THE MARYLAND-NATIONAL CAPITAL PARK AND PLANNING COMMISSION

MCPB
10/17/02
Item #3

MEMORANDUM

DATE: October 10, 2002
TO: Montgomery County Planning Board
VIA: Joseph R. Davis, Chief *JRD*
Michael Ma, Supervisor *Mk*
Development Review Division
FROM: Mary Beth O'Quinn *mboq*
Planning Department Staff
(301) 495-4571
REVIEW TYPE: Site Plan Amendment
(with concurrent Preliminary Plan Amendment 1-01004B)
APPLYING FOR: Approval of 36 single-family-detached lots in the R-200/TDR-3 Zone
PROJECT NAME: Ramsburg/Mills II/Roberts Property
CASE #: 8-01019B
REVIEW BASIS: Sec. 59-C-1.393 of the Zoning Ordinance
ZONE: R-200/TDR-3
LOCATION: On the north side of Travilah Road, approximately 4,000 feet east of its intersection with Dufief Mill Road
MASTER PLAN: Potomac Subregion
APPLICANT: Classic Communities c/o Chuck Sullivan
FILING DATE: August 11, 2002
HEARING DATE: October 17, 2002

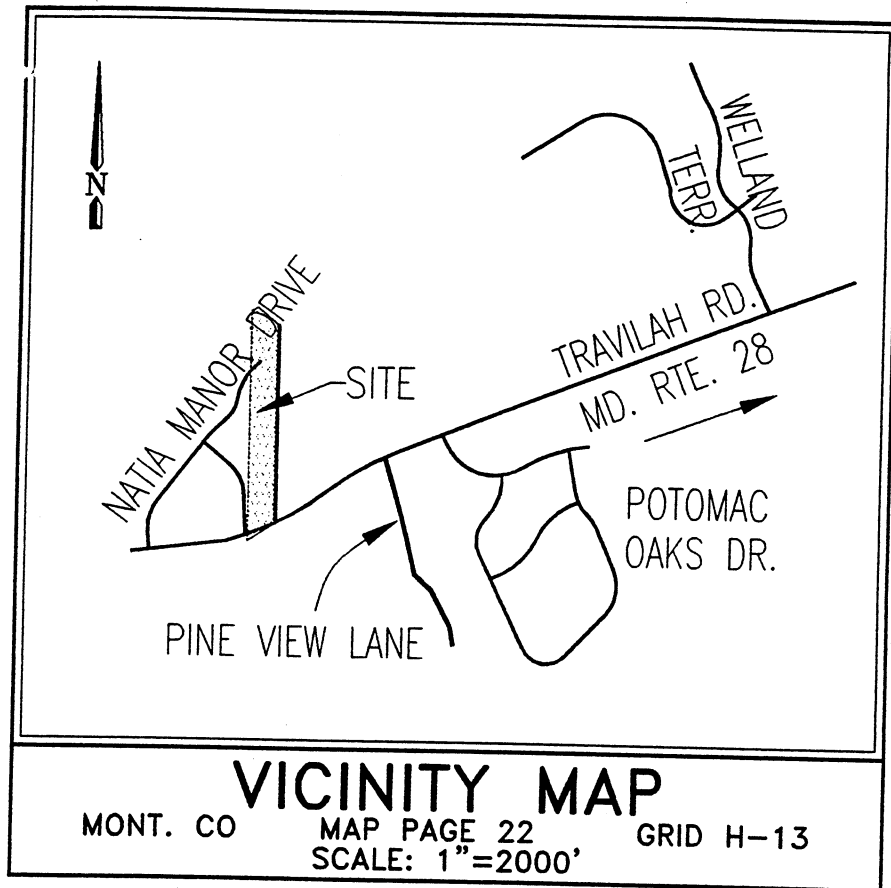
The subject site plan, “The **Roberts Property**,” comprises the second amendment to the site plan originally approved by the Planning Board as the **Ramsburg Property** on May 10, 2001. The Ramsburg site plan consisted of 15 single family homes within the eastern third of the presently combined site. This subdivision approval and site plan established the public road entry, Natia Manor Drive, and is noted on the below plan as Phase One.

The first amendment to the plan, known as the **Mills II Property**, was heard and approved by the Planning Board on October 18, 2001. This amendment added 15 single family homes to the subdivision, utilizing the land area immediately adjacent to the west. The design of Natia Manor Drive was extended to the west with a connecting north-south cul-de-sac, Ramsburg Court. The Mills II section is noted on the plan as Phase Two.

The current application proposed to add an additional area of land, “The **Roberts Property**,” to accommodate 12 additional houses that will complete the street line of Natia Manor Drive and line Ramsburg Court, facing east. Both the Preliminary Plan 1-01004B and the Site Plan are the subject of this amendment.
